# ATLAS Muon MDT

# MROD-X Pre-Production Series Test Report

Document Version: 1  
Document Issue: 1  
Document ID: ATLAS-TDAQ-2006-XXX or EDMS Id XXXXXX  
Document Date: 07-Dec-2006  
Document Status: Draft

Fifteen pre-production modules were produced. This document describes the issues found during testing.

Figure 3: Damaged front panel

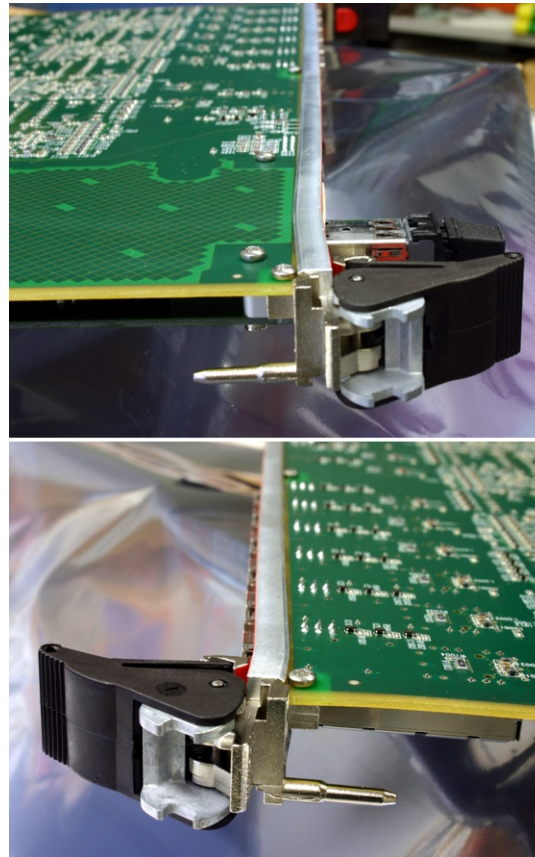
As a result of the poor packaging the front panel of one module was severely damaged (figure 3).

Improve packaging; Boxes broken (Front panel suffered)

Figure 4: poorly soldered fuses

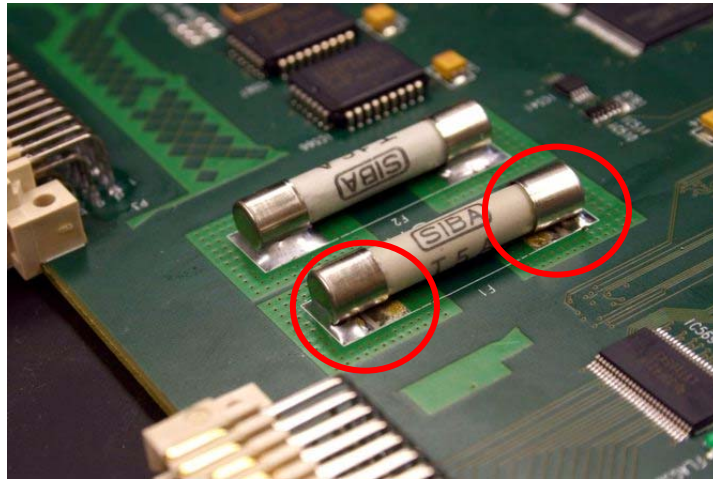
Before a closer inspection of the soldering joints, the eye was caught by the soldering joints of the fuses (see figure 4). It should be noted that these fuses are not made to be used as surface mount devices. However, the excessive currents drawn force us to solder the devices directly onto the board, rather than to use a fuse-holder that would cause too much contact resistance.

When heating the fuses, the end-caps tend to be blown off by the expanding hot air inside the fuse. So one need to find an optimum in reflowing the solder and trying to keep the end-caps in place.

Improve soldering of the Fuses. Try to keep the end-caps in place while reflowing the solder.

Figure 5: this example shows how the connectors on the prototype (not assembled by PCB Technologies) was mounted with rivets

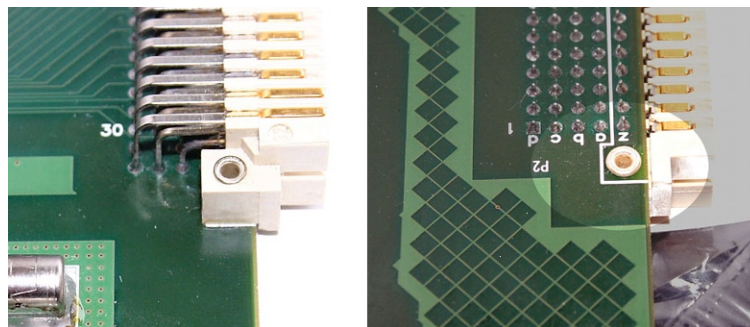
Originally it was asked to mechanically fix the P1, P2 and P3 connectors with rivets. Figure 5 for example, shows how the connectors on our proto type series were mounted.

When the boards were already assembled it became clear that PCB Technologies could not supply these rivets. It has been agreed to ship the pre-production series without a mechanical fixation on P1, P2 and P3 and to fix the connectors in Amsterdam.

For the main series one should first mechanically fix the connectors and than solder the connectors. The other way around may cause stresses in the soldering joint that could cause it to malfunction over time.

Mechanically fix P1, P2 and P3 before soldering

Figure 6: R523 should be 1M (not 0Ω) and R524 should be 0Ω (not 1M)

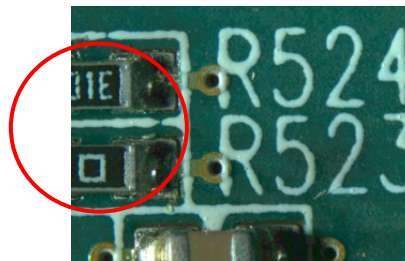
Pictures of the wrongly placed resistors were made (figures 6 to 9 below)

R523 should be 1M (not 0Ω)

R524 should be 0Ω (not 1M)

Figure 10: A 10 ohm resistor!

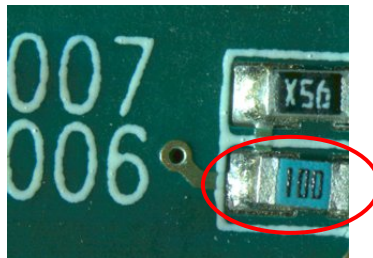
There are many (switched mode) power supplies on the board. The feedback resistors need to have the proper values to avoid over-voltage on the FPGAs or SHARC processors. All resistors had the proper value, except for one. It seems that there was a wrong tape placed on the machine since for all 100 ohm resistors, 10 ohm resistors were placed instead. This involves 15 resistors per module (R605, R608, R609, R610, R719, R720, R721, R1006, R2006, R3006, R4006, R5006, R6006, R7006, R8006)

The proper EIA-96 marking for a 100 ohm smd resistor should read "01A". However resistors with marking "100" were placed. This is not an EIA-96 marking and should be read as 10 times 10 to the power of 0, thus 10 ohm (see figure 10).

R605, R608, R609, R610, R719, R720, R721, R1006, R2006, R3006, R4006, R5006, R6006, R7006, R8006 should be 100 ohm (not 10Ω)

Figure 11: IC548 orientation 180 degrees

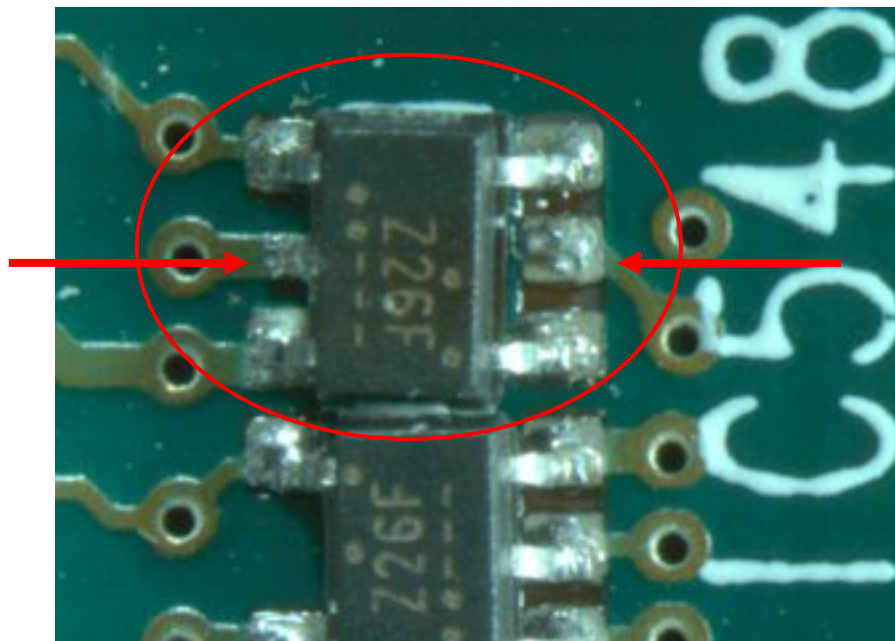
### 4.2 Module 12, IC548 has wrong orientation

This error is most peculiar since the NC7SZ126P5X is delivered in a tape. In the factory these devices are automatically packed into this tape so it is not likely that a device is taped with the wrong orientation... What happened here?

Figure 12: R204 pad not soldered propely

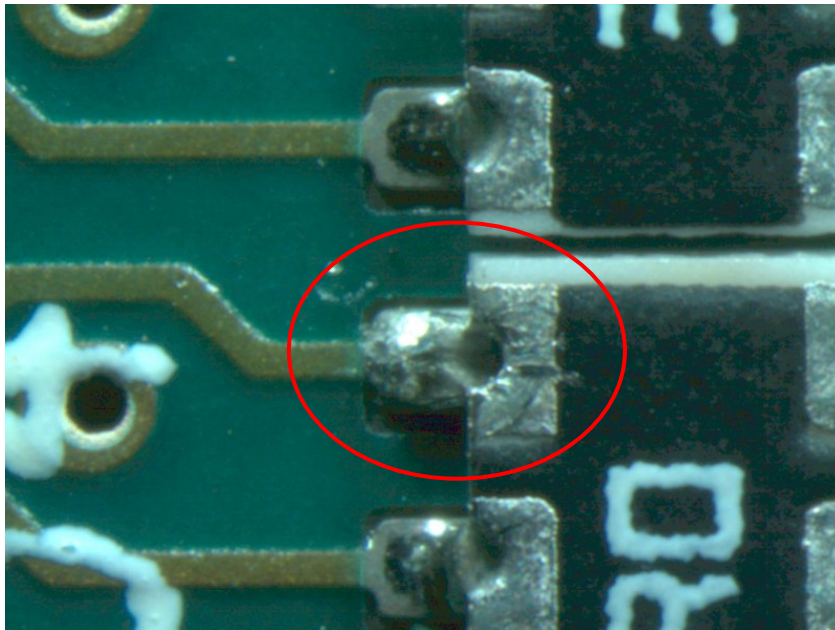
### 4.3 Module 12, Pad R204 was not soldered propely

Figure 13: IC588 pin 1 and 5 above the PCB and not soldered

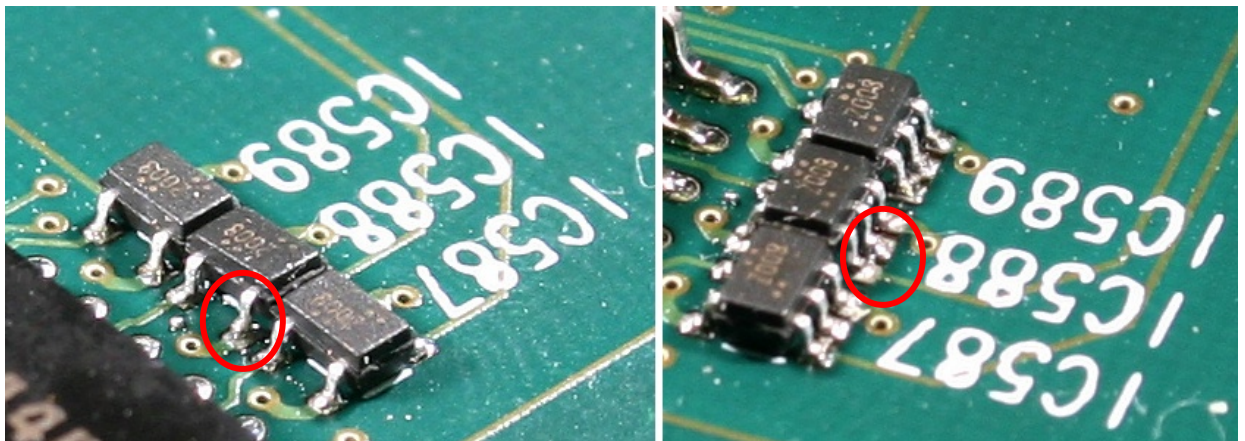
This fault is caused by the package of the NC7SZ00P5X which is not really flat on the PCB thus causing the pins to stand off from the PCB surface.

This seems to be a problem area on the board because the packages are too close together. See also paragraph 4.7. Extra attention is needed to make sure that these ICs are properly soldered.

Pay special attention to IC588 area

Figure 14: J24 pin 2 is not soldered

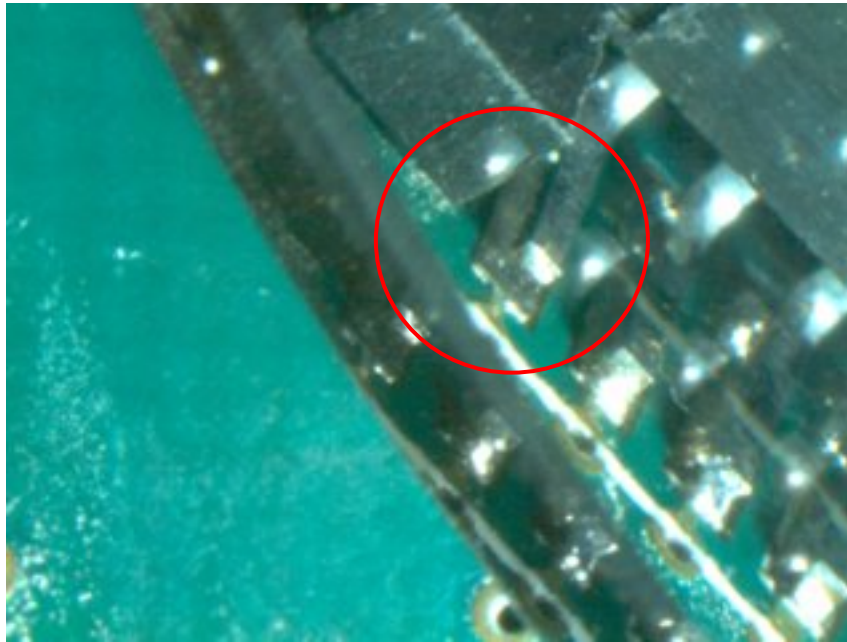
This fault is caused by the connector which is not really flat on the PCB thus causing the pin to stand off from the PCB surface. Note the picture was made using a mirror.

Figure 15: Loose pin 19 on connector IC2001

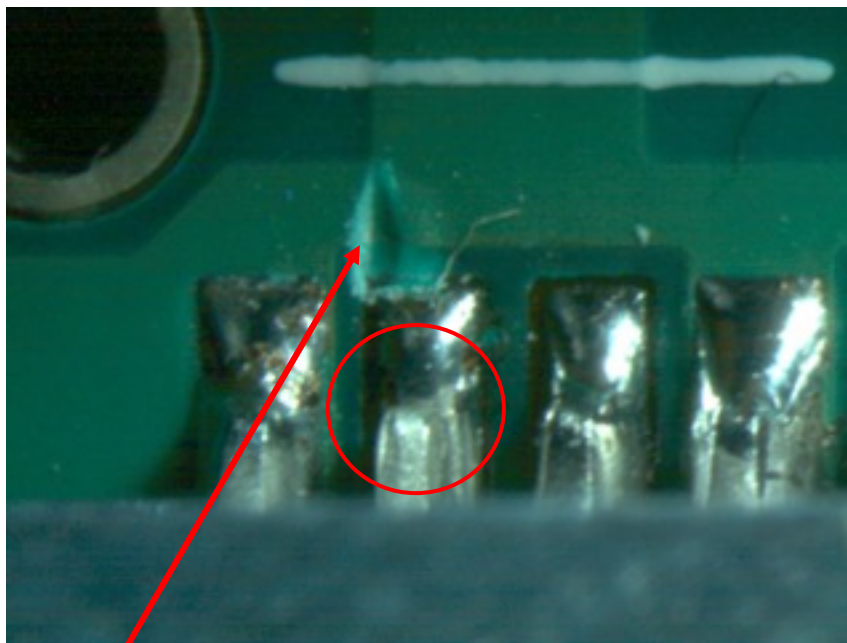
This is caused by the screw driver, used unlock the cage...

Figure 16: IC588 pin 3 not soldered

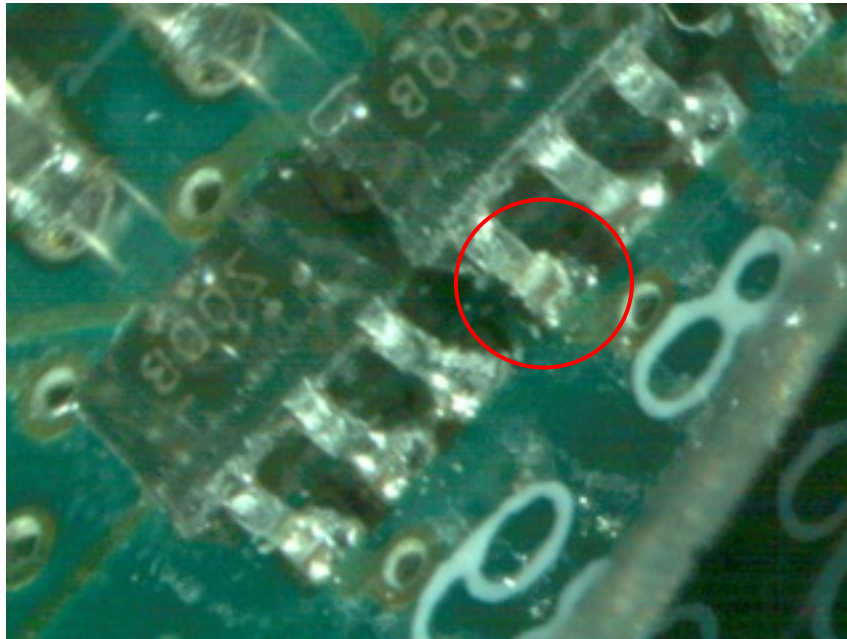
Mind the blurred picture; it was made using a mirror. This fault is caused by the package of the NC7SZ00P5X which is not really flat on the PCB thus causing the pins to stand off from the PCB surface.

This seems to be a problem area on the board because the packages are too close together. See also paragraph 4.4. Extra attention is needed to make sure that these ICs are properly soldered.

Figure 17: IC548 pin 2 not soldered

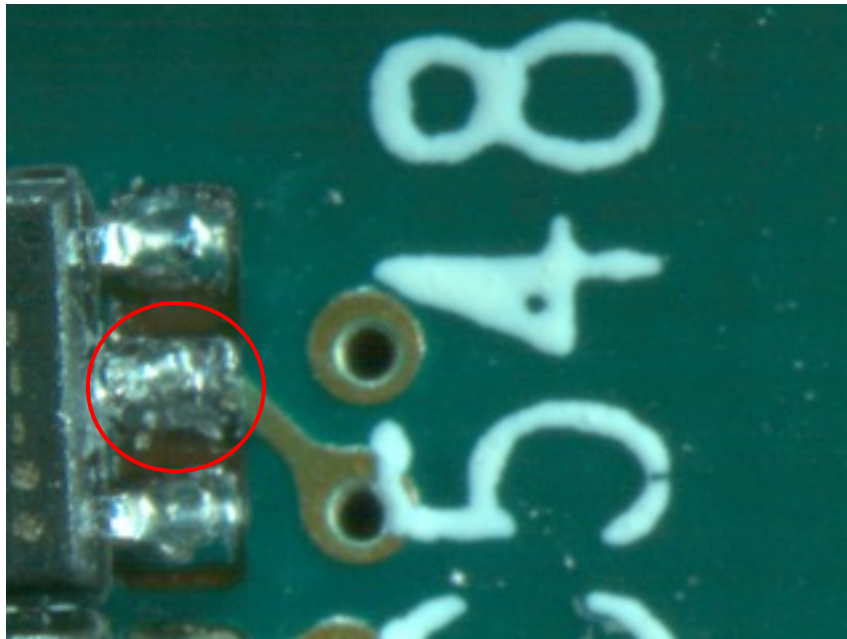
This is one of the errors that would have been difficult to find for an Automatic Optical Inspection.

Use Automatic Optical Inspection (AOI) of the assembled boards to lower the failure rate

Figure 19: Trace 1: MRI\_D4; Trace 2: MRI\_CCLK (@ 40 MHz), Cursors at 0.8 Volt.  
Termination 3V3 -> 82 ohm -> MRI\_D4 -> 130 ohm -> Ground

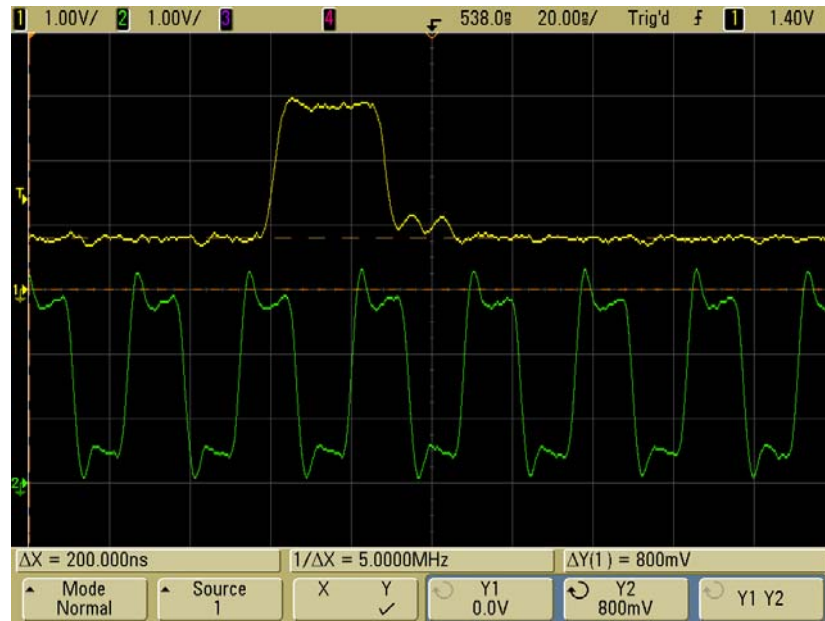
However, certain modules (V2) sometimes did not configure properly. Investigation of the configuration bus data bits shows that the signals marginally come below 0.8 Volt (see figure 19).

It was chosen to remove the termination resistors (R676a-h, R677a-h) for the data bits and to lower the configuration frequency from 40 to 20 MHz to avoid the reflections on the lines. In fact this same scheme was used successfully on the six prototype modules (V1a).

Don't place R676a, R676b, R676c, R676d, R676e, R676f, R676g, R676h

Don't place R677a, R677b, R677c, R677d, R677e, R677f, R677g, R677h

Figure 20: Trace 1: MRI\_CCLK (@ 20 MHz), Cursors at 0.5 Volt. Termination 3V3 -> 130 hm -> MRI\_CCLK -> 82 ohm -> Ground. MRI\_CCLK low level stays below 0.5 V

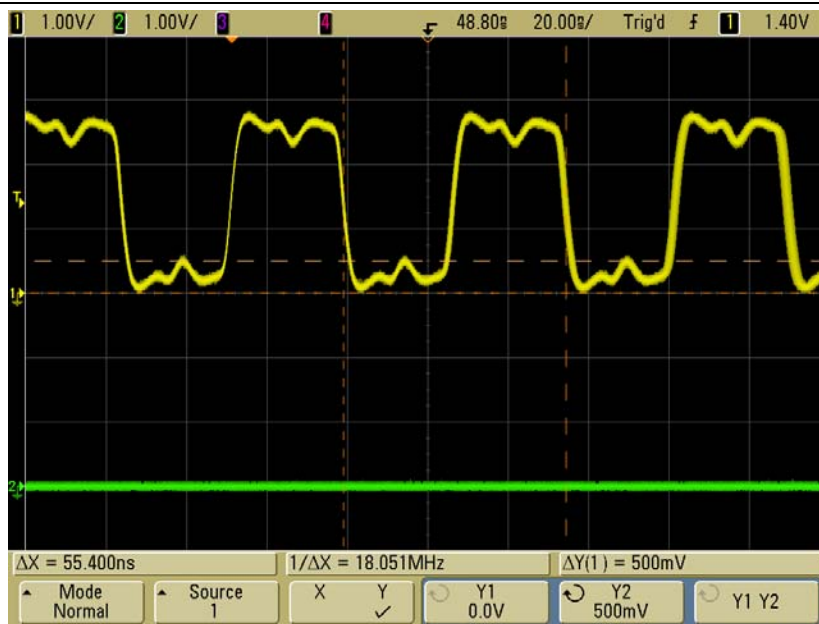
On the proto type modules (V1a), the clock line was terminated in a 100/100 ohm fashion. For the pre-production (V2) series it was chosen to use a more conventional TTL scheme of 82/130 ohm (resistors R672 and R675). The Thevenin equivalent voltage for this termination is 2 Volt which turns out to be too high since the sink capability of the drivers in the configuration PROM (XCF08P) is not very strong. Therefore the termination scheme was changed to 130/82 ohm which has a Thevenin equivalent voltage of 1.2 Volt. The resulting clock signal can be seen in figure 20.

Place R672 130 ohm (not 82)

Place R675 82 ohm (not 130)

Figure 21: spurious triggers on the output of the ttc\_bus\_bit\_fifo\_1x15 (internal in the FPGA)

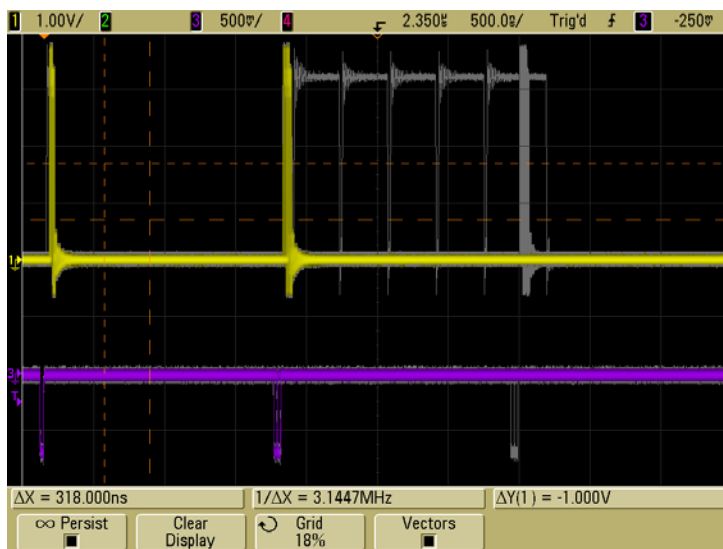
While trying to start a duration test with the MROD-X built in test pattern generator, it was found that the L1-Accept trigger signal that is supplied by the TIM module was not properly interpreted by the FPGA from Channel 2B.

After thorough inspection the problem was reduced to the termination of the LHC\_Clk2 line. The FPGA input appears to be very sensitive in the 1.2 Volt region. On the falling edge, a hick-up can be seen (figure 22 below). This hick-up sometimes confuses the flags of the “ttc\_bus\_bit\_fifo\_1x15”. This FIFO (internal in the FPGA) is used as a bridge for the L1A signal from the LHC-Clock domain to the MROD-In system-clock domain. When the flags of this FIFO get confused then the FIFO behaves like “falling through the empty flag”, thus generating 16 spurious triggers on its output (figure 21).

To solve this problem, the termination of the LHC\_Clk lines was changed. The best results are obtained when a resistor is placed to ground thus the Thevenin equivalent voltage is zero in order to get the hick-up as far as possible from the 1.2 V region. Resistors of 82, 68 and 51 ohm all worked fine but 51 ohm is chosen since it is closest to the trace impedance and farthest from the 1.2 V region.

Figure 22: Hick-up in the LHC\_Clk2

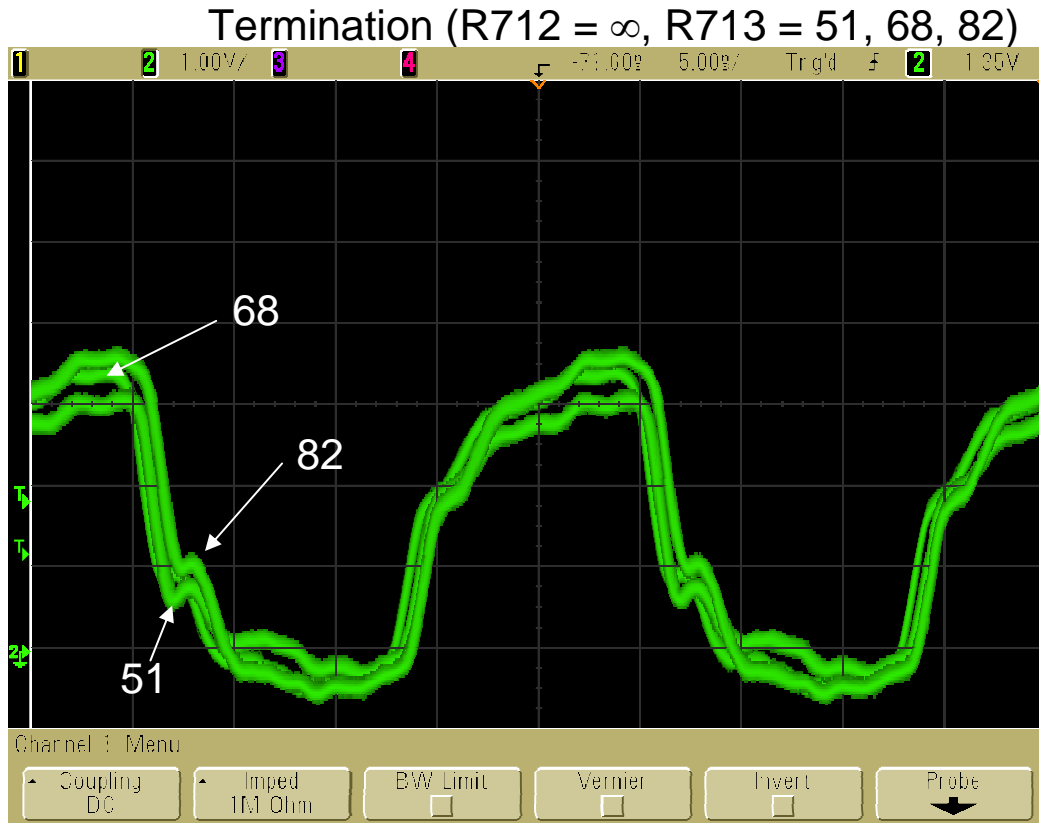
The hick-up on the LHC\_Clk2 line is not caused by a termination problem. The whole line is perfectly 50 ohms which was measured by a Time Domain Reflectometry (TDR). This shows that the Printed Circuit Board was manufactured with great care! The TDR also showed that the trace length is 4.4 ns (80 cm). The hick-up is caused by loss (in the FR4 material) of high frequency components and capacitive loading on the FPGA input pins.

The LHC\_Clk2 signal was compared the other LHC\_Clk signals for the other FPGAs on the module as well as the same signal found on the prototype series (V1a). The signals found are comparable although the phenomena is only present on the pre-production series (V2), only on Channel 2B. This shows how marginally this signal is. Differences in trace routing (as compared to the other MROD input channels) or differences in Printed Circuit Board material and/or another batch of FPGAs (as compared to the proto-type series) can explain this behavior.

Don't place R710, R712, R714, R716

Place R711, R713, R715, R717 = 51 ohm (not 130)

Figure 23: J22 should not have been placed

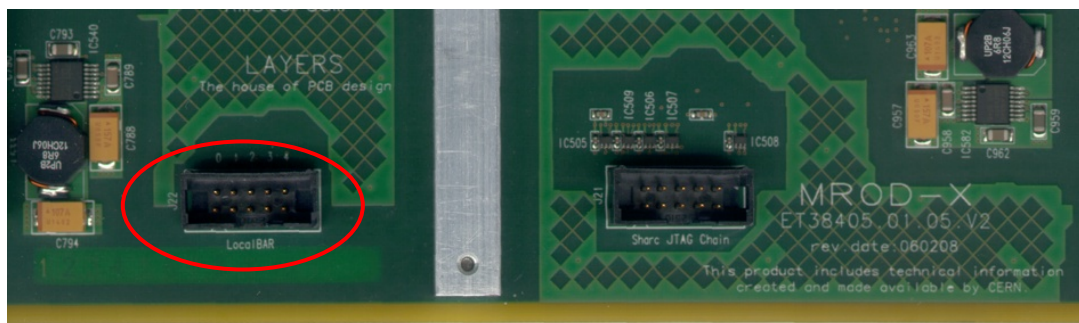
The fifteen pre-production modules all have a 2x5 pin boxed header placed for J22 (see figure 23) as was wrongly specified in the “assembly list”. For the series we kindly ask **not** to place these connectors.

Note that there were 275 2x5 pin boxed headers delivered to PCB Technologies (for mounting J21 = item 24). This amount included 20 spare connectors. For the pre-production series there are 15 connectors placed (for J22) so the amount of spare connectors is now reduced to 5.

Don't place J22 (Bar jumper 2x5)
